Rezoning 2-RZ-2024
Applicant: Spartak Selmiaj

Property: 1696 Dyer Road, (parcel #160-000860)

Request: To amend Exceptional Use District

Formal Technical Review

Concept Site Plan

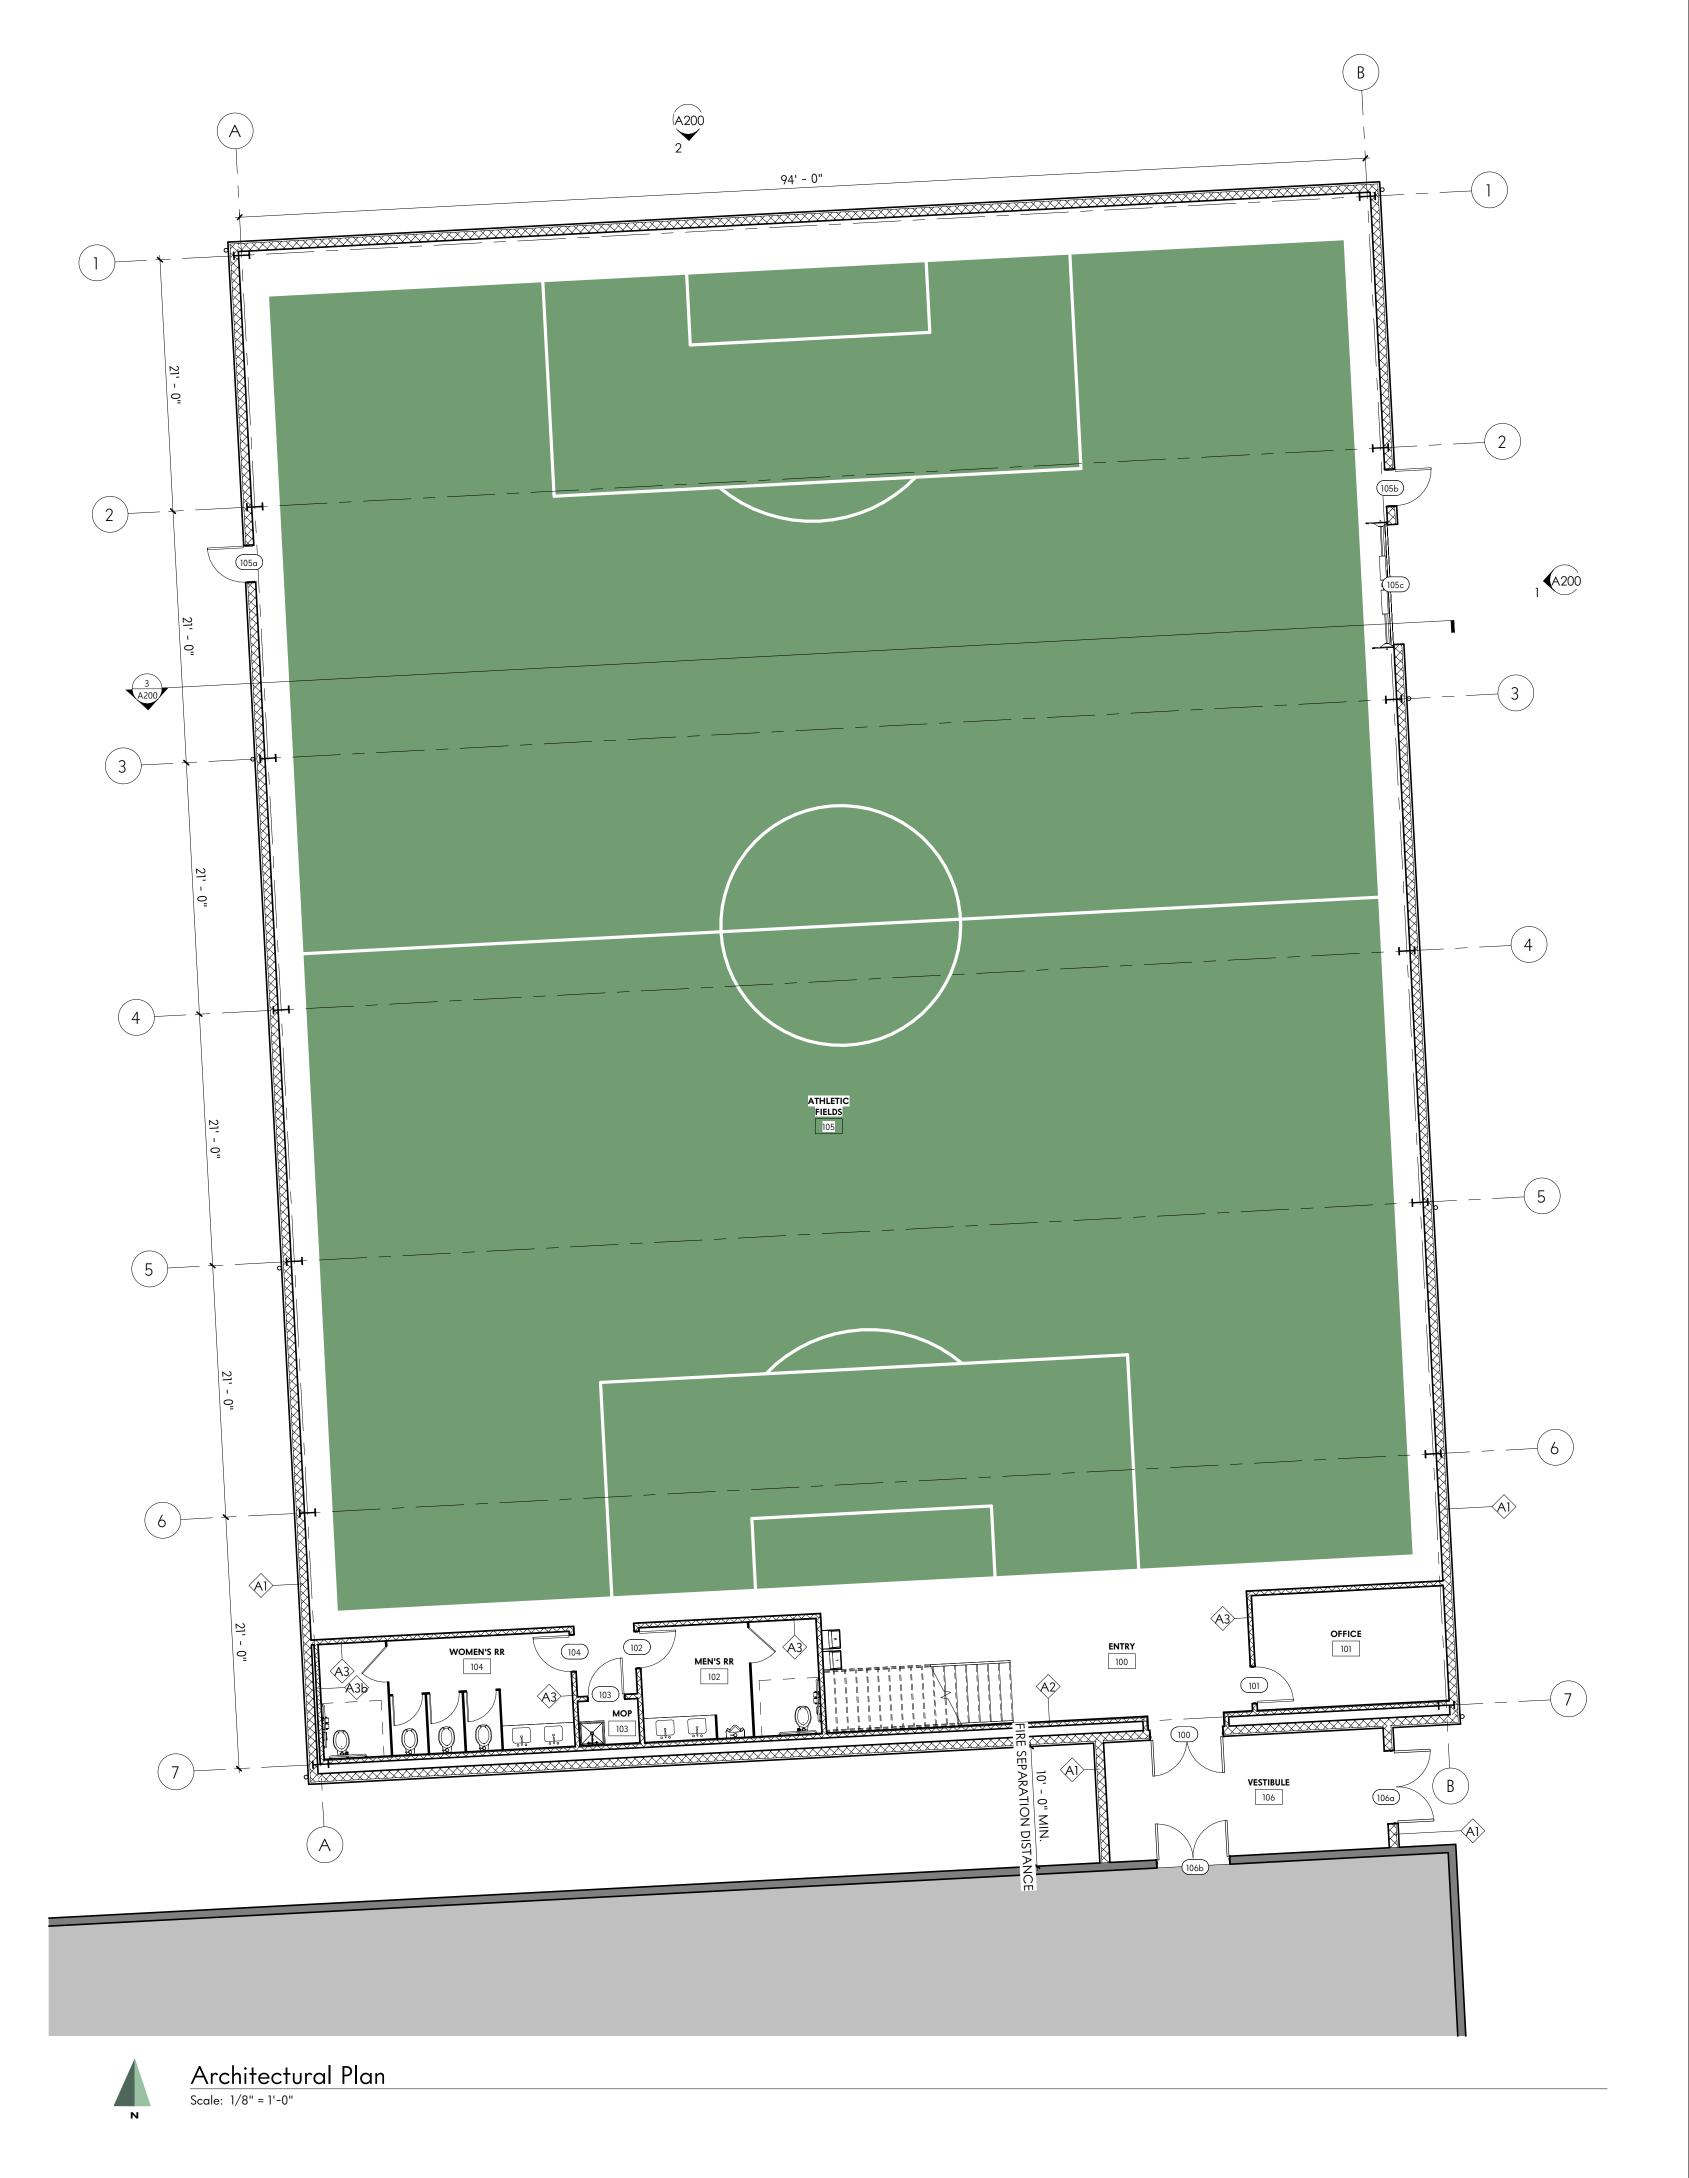
- 1. The proposed location and size of areas of use, indicating size, location and type of structure.
 - a. The development plan includes details of the proposed structures, fields, parking, and accessory development. Not included in the plan are details on stormwater drainage, signage, traffic, trash maintenance, lighting, and the type of landscaping proposed.

- 2. The proposed location, size and use of all open areas landscaped and other open space with suggested ownership of such area.
 - a. The development plan displays all open areas of the athletic fields, in addition to all landscaped open areas elsewhere on the site. Details on landscaping are limited and do not provide the information necessary to determine compliance with the regulations.

- a. The site has a previously approved access from Dyer Road from Jackson Township. Additional parking facilities are proposed to accommodate patron use of the additional athletic fields. An additional pedestrian path is proposed adjacent to the extended open parking areas. Patrons will access playing fields over natural grass surrounding the fields.

- b. Jackson Township Planning Department will confirm required parking is provided through their zoning compliance review. The required number of spaces have been provided on the plan; however, the spaces do not meet the minimum dimensional Township requirements of 10 ft. by 20 ft.

- a. No development text has been provided to elaborate on the proposed rezoning and development. A development plan showing the location of the athletic fields and extension of the indoor facility has been included in submitted material. A schedule on the proposed development at the site, stormwater drainage plans, access impact study, or landscaping plans has not been provided to the Franklin County Planning Department.
